# Innovation Competitions - Full Submission

## Supplementary Answer Form

Project code	SSET2/07	Question Number	1
Question date	31/7/2014	Answer date	1/8/2014
Submission section question relates to	1.3 Project Summary		
Topic	Project Methodology

Fig.1 SEP D Transformer Efficiency against EU Requirements

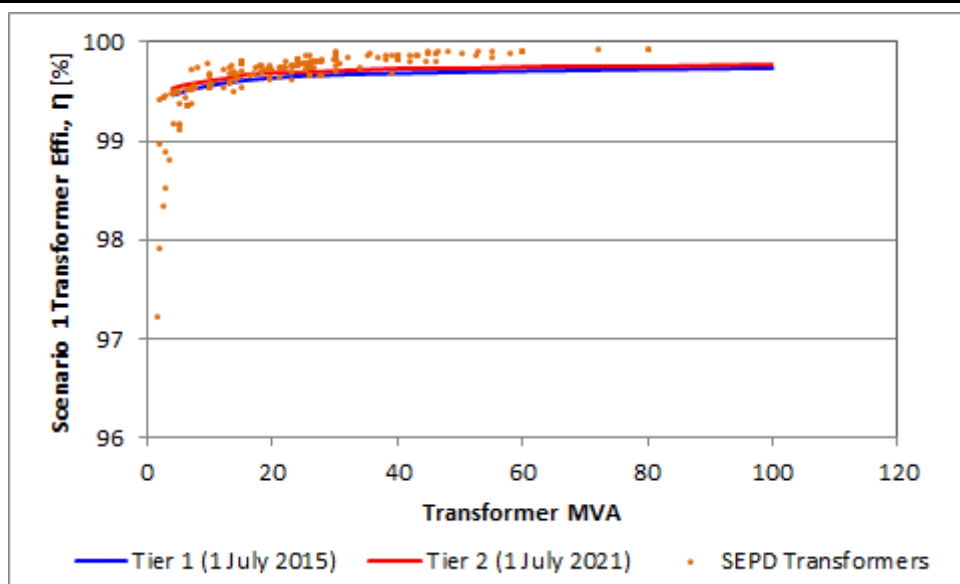
Question	When calculating the benefits it appears that you have not taken into account that transformer losses will naturally be reducing due to the EU directive. Why?		
Notes on question

Answer	<p>The EU Directive 2009/125/EC only applies to transformers purchased after the regulation comes into force. The Directive specifies incremental transformer efficiency specification in two separate phases: Tier 1 to commence from 1<sup>st</sup> Jul 2015, and Tier 2 from 1<sup>st</sup> Jul 2021.</p> <p>Fig.1 shows transformer capacity (MVA) versus peak efficiencies for all existing SEPD's 33/11 kV primary transformers plotted against the EU Directive Tier 1 (blue curve) and Tier 2 (red curve) requirements. Among these primary transformers, only 17.1% fall below the EU Directive's Tier 1 transformer efficiency specification, and 25.2% below the Tier 2 specification. In other words, the majority of SEPD's transformers already comply with, or are more efficient than, the EU Directive's Tier 1 and 2 specification. It must also be noted that there is no requirement to replace existing transformers that do not comply with the directive.</p> <p>Assuming a 60 year (typical) transformer life, we do anticipate that a number of transformer replacements due to end of life replacements are likely to occur during the next 15 years, i.e. from 2015 up to 2030. The approximate expected replacement rate is in the region of four to five sites per year.</p> <p>The LEAN project will however, focus the initial study work on the transformers that fall outside the directive requirements and hence provide a better return on investment. Therefore, from a SEPD's perspective, the impact of EU Directive on presented LEAN business case is expected to be minimal.</p>
